BURRIS/WAGNON ARCHITECTS, P.A.

ADDENDUM NO. 3

Re: **GS# 505-030**
Fire Station Dormitory
State Fire Academy
Pearl, Mississippi

EXHIBIT "B"
SHEET 1 OF 1
(FROM DRAWING SHTS. 2.2 & 2.3)

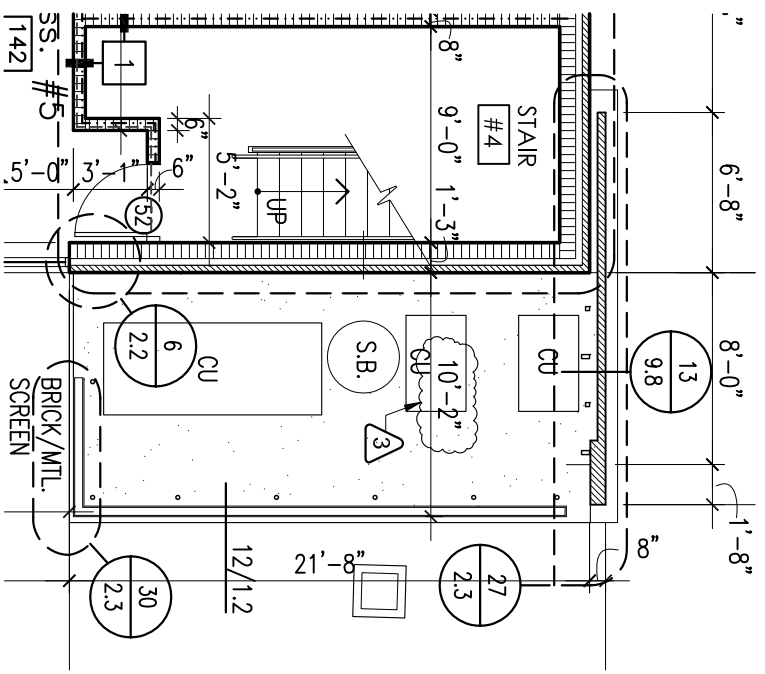
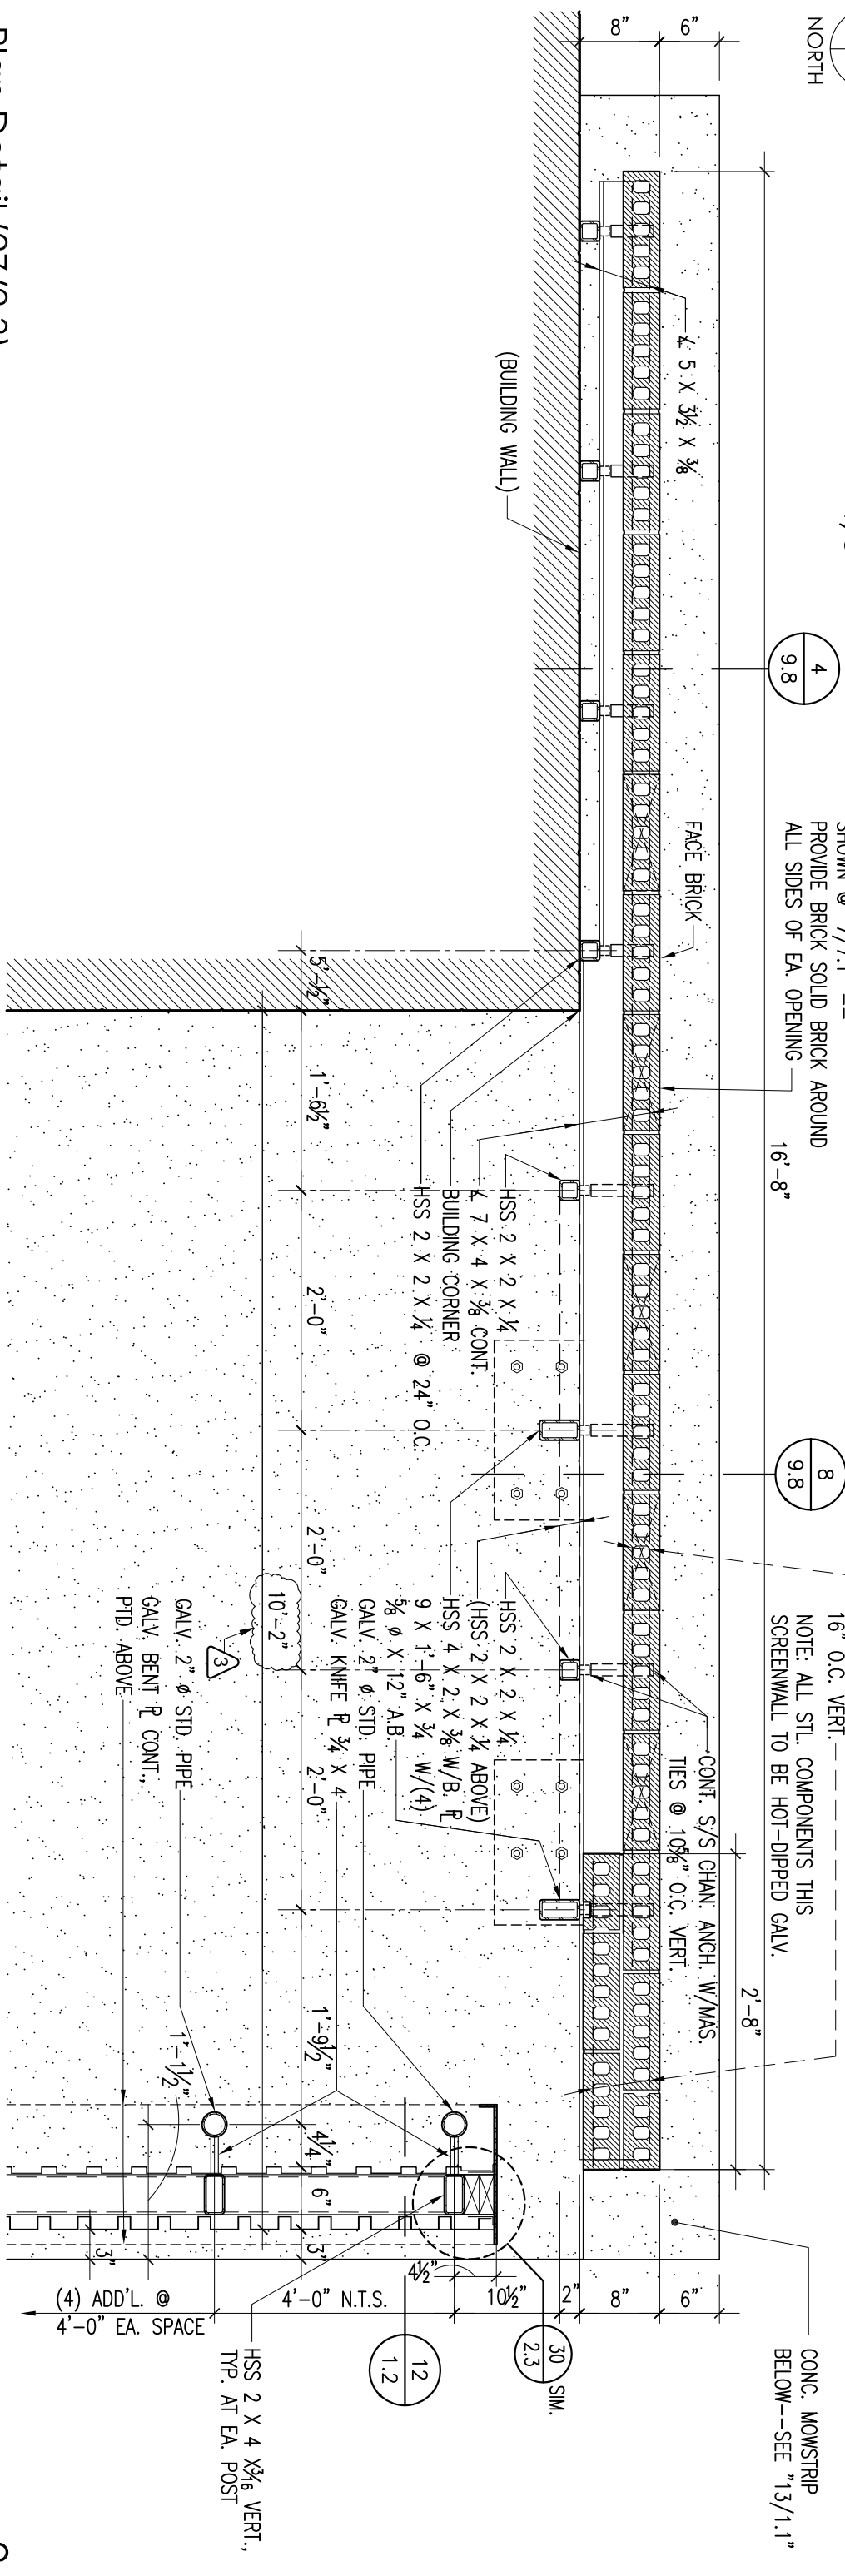
- Item No. 2:** Refer to Sheets 2.2 (drawing "3", Partial First Floor Plan – Part "B") and 2.3 (detail "27") and extend the Building "B" equipment pad slab north edge 2'-2" to the north (metal fence to extend out with slab), per attached Exhibit "B".

M1.1AR1

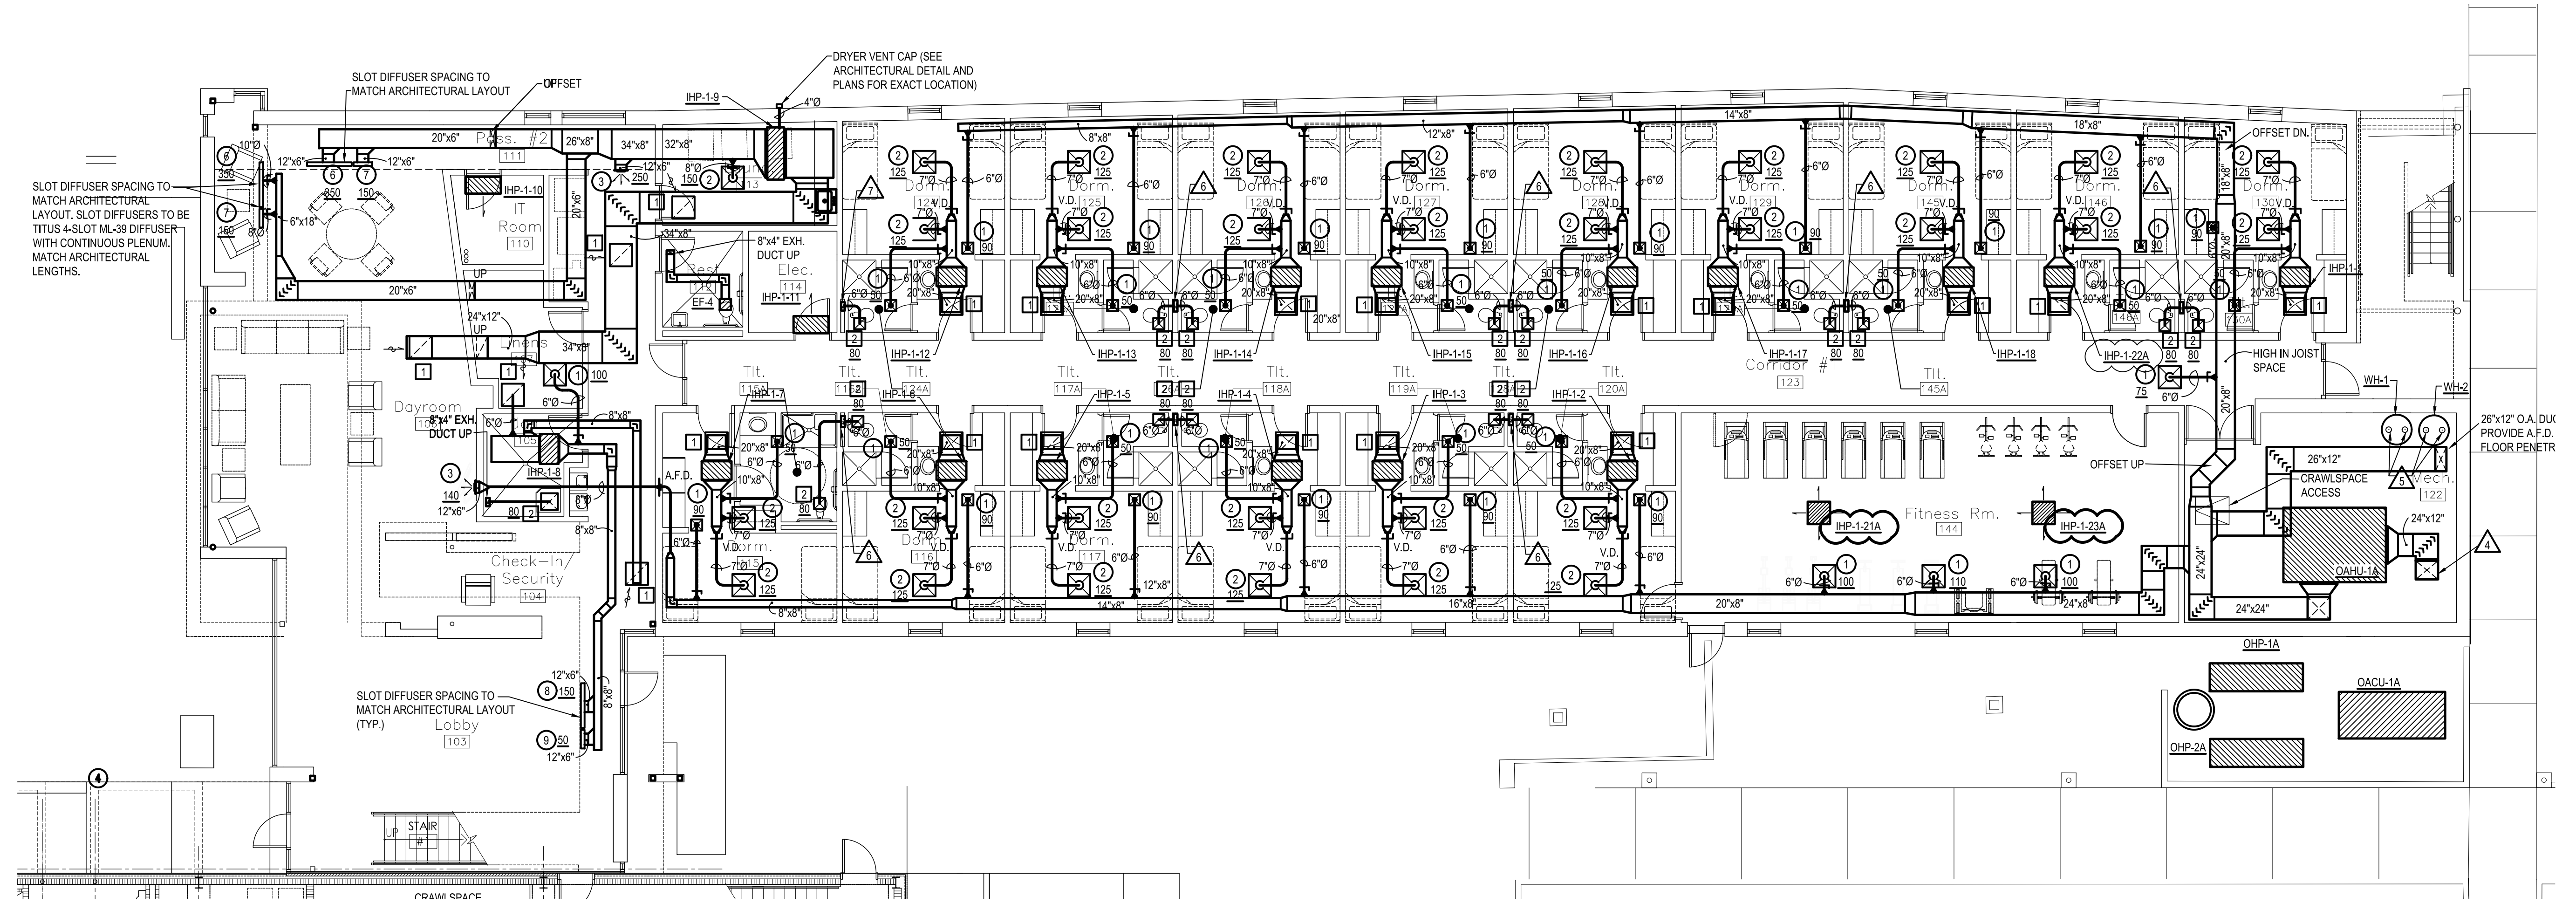
- Item No. 6: Drawings, Sheet M1.1A, MP1.1A, MP1.2A, and P1.1A: Replace with the attached Sheets M1.1AR1, MP1.1AR1, MP1.2AR1, and P1.1AR1 correcting the indoor heat pump tags on the dorm alternat sheets.
